**BULLETIN NO. 17/18-011 DATE: 20 Nov 2017**

**SUBJECT: 2018 600RS Ski-Doo Internal cab temperature**

Date: November 20th, 2017  
Recipient: 2018 600RS Ski-Doo Owners  
Subject: Internal cab temperature

**2) ADDITION OF NEW HOLES IN THE LEFT SIDE PANEL**

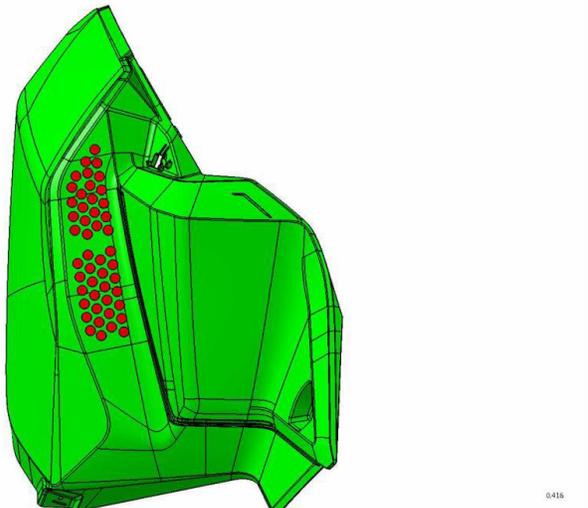
Please add new holes in the left side panel.

- The diameter of the holes are 1/2".
- 48 holes total.
- Please see picture below for location of the holes to be added.
- Please see the hole pattern attached in the same e-mail as tip sheet #5. The location of the holes is critical. Make sure to use the pattern provided.

LEFT SIDE FRAME OPENING

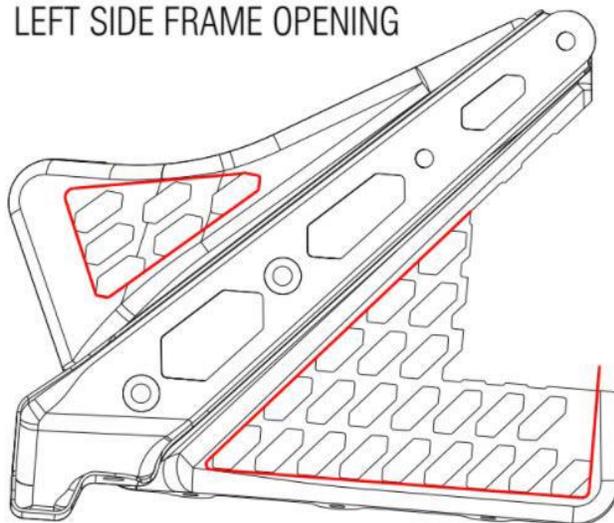
### 3) CREATION OF GREATER HOLES BEHIND THE LEFT FOOT HOLDER

- You need to cut the openings per the red lines below. Again, the idea is to add the flow of cold air inside the cab. Please see the picture below.

TRIM THE BELT-GUARD  
AS SHOWN

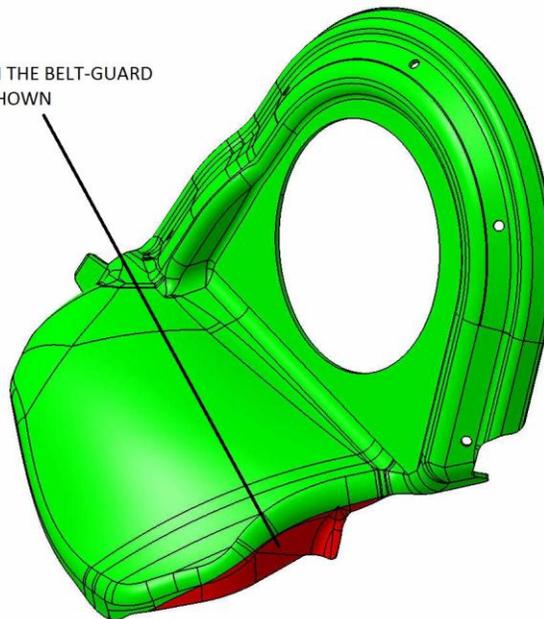
### **1) BELT GUARD MODIFICATION**

- In order to add air flow inside the cab, please cut the area in red as shown in the picture

## 2) ADDITION OF NEW HOLES IN THE LEFT SIDE PANEL

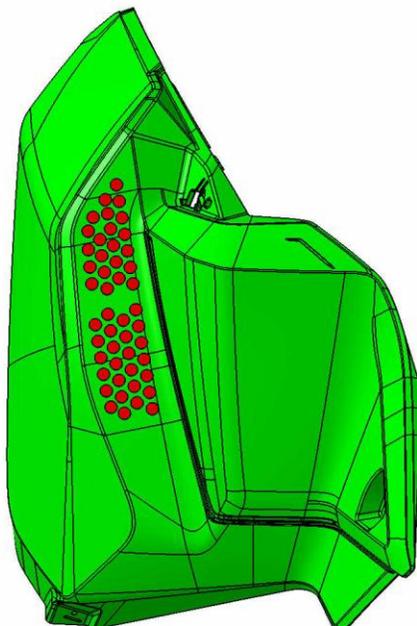
Please add new holes in the left side panel.

- The diameter of the holes are 1/2".
- 48 holes total.
- Please see picture below for location of the holes to be added.
- Please see the hole pattern attached in the same e-mail as tip sheet #5. The location of the holes is critical. Make sure to use the pattern provided.

LEFT SIDE FRAME OPENING

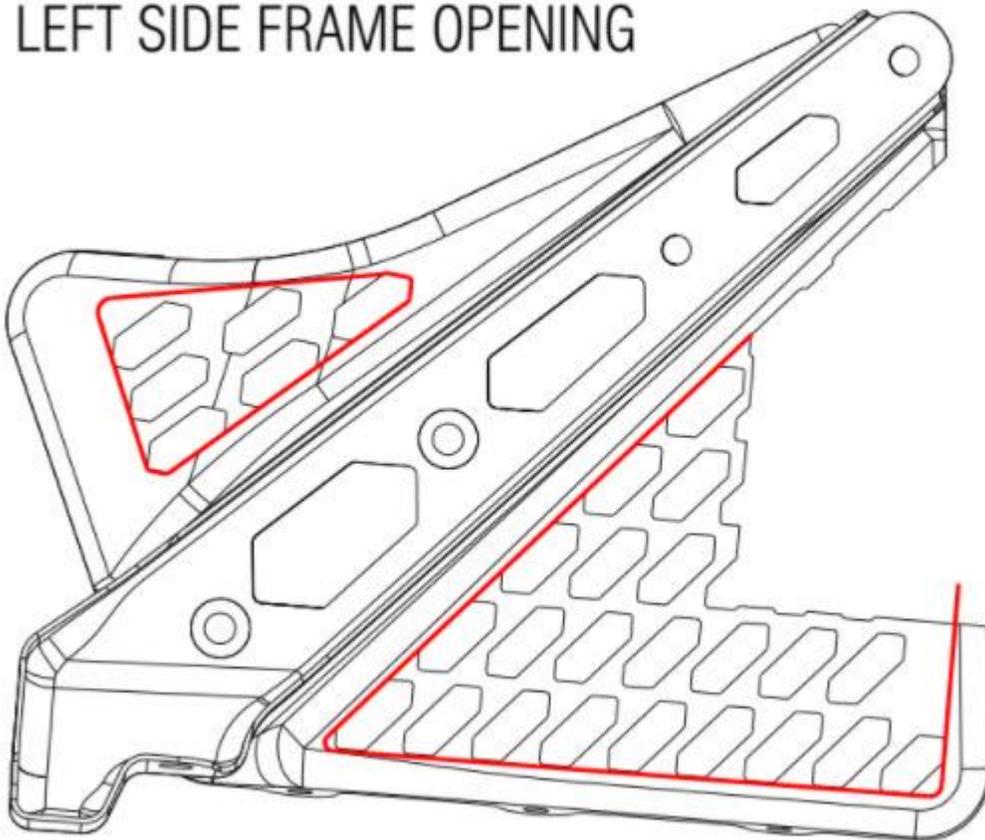
### 3) CREATION OF GREATER HOLES BEHIND THE LEFT FOOT HOLDER

- You need to cut the openings per the red lines below. Again, the idea is to add the flow of cold air inside the cab. Please see the picture below.

## 4) INSIDE CAB SNOW INGESTION

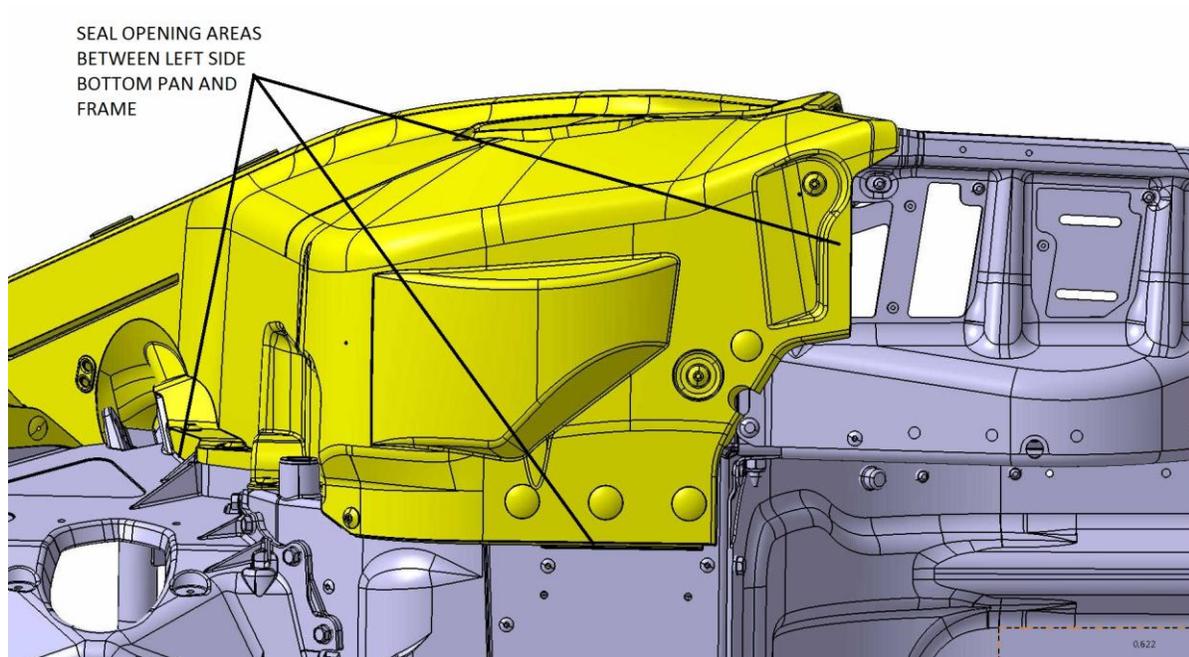
- Please block the openings (silicone) between the frame and the left side bottom pan to prevent in-cab snow ingestion. Please see picture below.
